Project Description: Flats at 47th

Project/File: **Flats at 47th / GC26-0009 / DSRFY2026-00012**
This is a design review application to allow for the development of a 16 unit multi-family residential building on 0.45 acres.

Lead Agency: Garden City

C. Site Plan

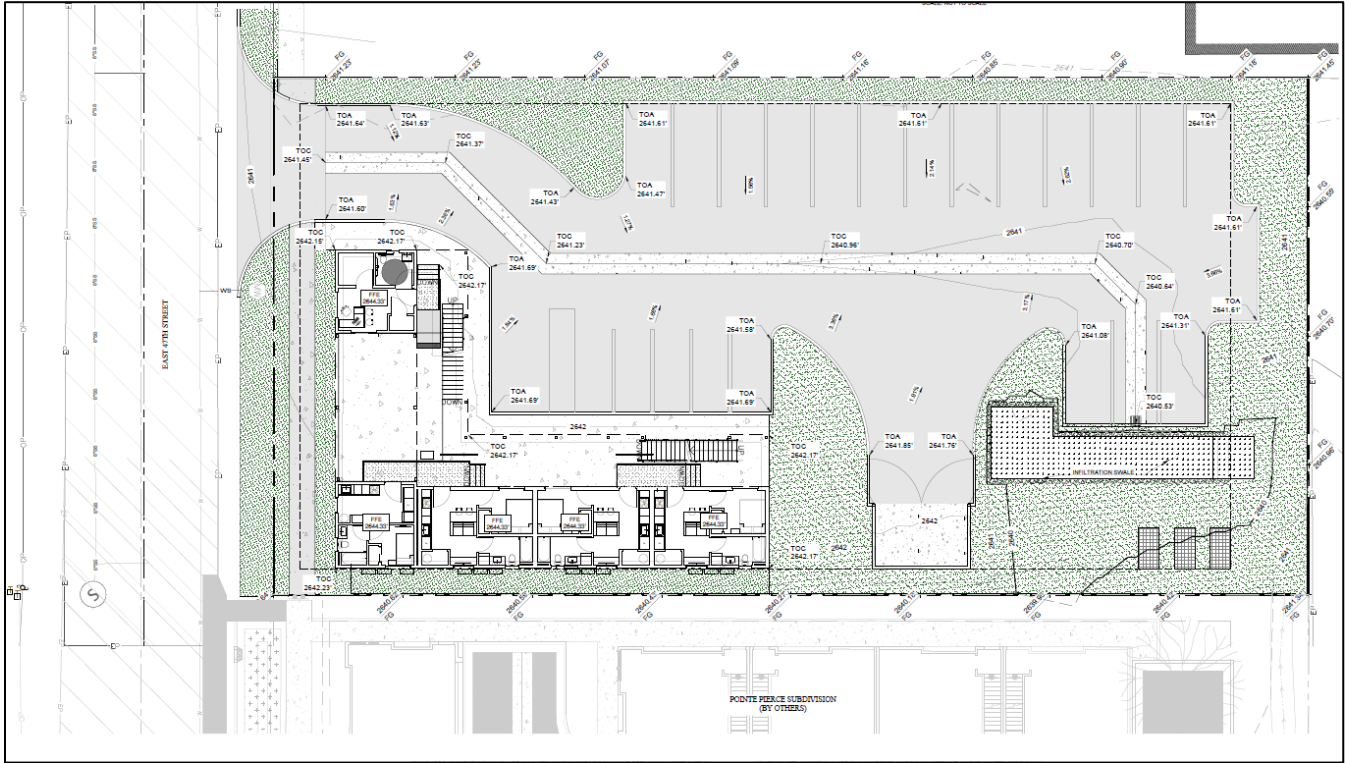
- a. **Existing Conditions:** 47th Street is improved with 2-travel lanes and no curb, gutter or sidewalk abutting the site. There is 51-feet of right-of-way for 47th Street (25-feet from centerline).
- b. **Applicant's Proposal:** The applicant is proposing to improve 47th Street with a 10-foot wide landscape strip and 5-foot wide detached concrete sidewalk.
- c. **Staff Comments/Recommendations:** The applicant's proposal does not meet District policy and should not be approved, as proposed. The applicant should be required to construct 47th Street as ½ of 36-foot wide commercial street section with vertical curb, gutter, and a minimum 5-foot wide attached concrete sidewalk. If a detached sidewalk is required by the City of Garden City, then a minimum 8-foot wide planter strip should be provided.

- a. **Existing Conditions:** There are no defined driveways from the site onto 47th Street.
- b. **Applicant's Proposal:** The applicant is proposing to construct a paved 23-foot wide curb return type driveway from the site onto 47th Street, located 407-feet northeast of Adams Street (measured centerline-to-centerline).
- c. **Staff Comments/Recommendations:** The applicant's proposal meets District policy and should be approved, as proposed.

1. Construct 47th Street as ½ of 36-foot wide commercial street section with vertical curb, gutter, and a minimum 5-foot wide attached concrete sidewalk. If detached sidewalk is required by the City of Garden City, a minimum 8-foot wide landscape strip should be provided.

2. Dedicate right-of-way to 2-feet behind back of sidewalk. For detached sidewalk, provide a permanent right-of-way easement from the existing right-of-way line to extend to 2-feet behind back of sidewalk. Sidewalk shall be located wholly within right-of-way or wholly within an easement.

3. Construct a paved 23-foot wide curb return type driveway from the site onto 47th Street, located 407-feet northeast of Adams Street.
4. If a multi-use pathway is to be constructed within or adjacent to the site, then the design of those facilities shall be consistent with ACHD's Multi-Use Path & Raised Bike Lane Tool Kit. Additional right-of-way dedication may be required at all intersections (streets and driveways) to accommodate setbacks. Contact Development Review with questions prior to plan submittal.

The applicant should be required to dedicate right-of-way to 2-feet behind back of sidewalk. For detached sidewalk, the applicant may provide a permanent right-of-way easement from the existing right-of-way line to extend to 2-feet behind back of sidewalk. Sidewalk shall be located wholly within right-of-way or wholly within an easement.
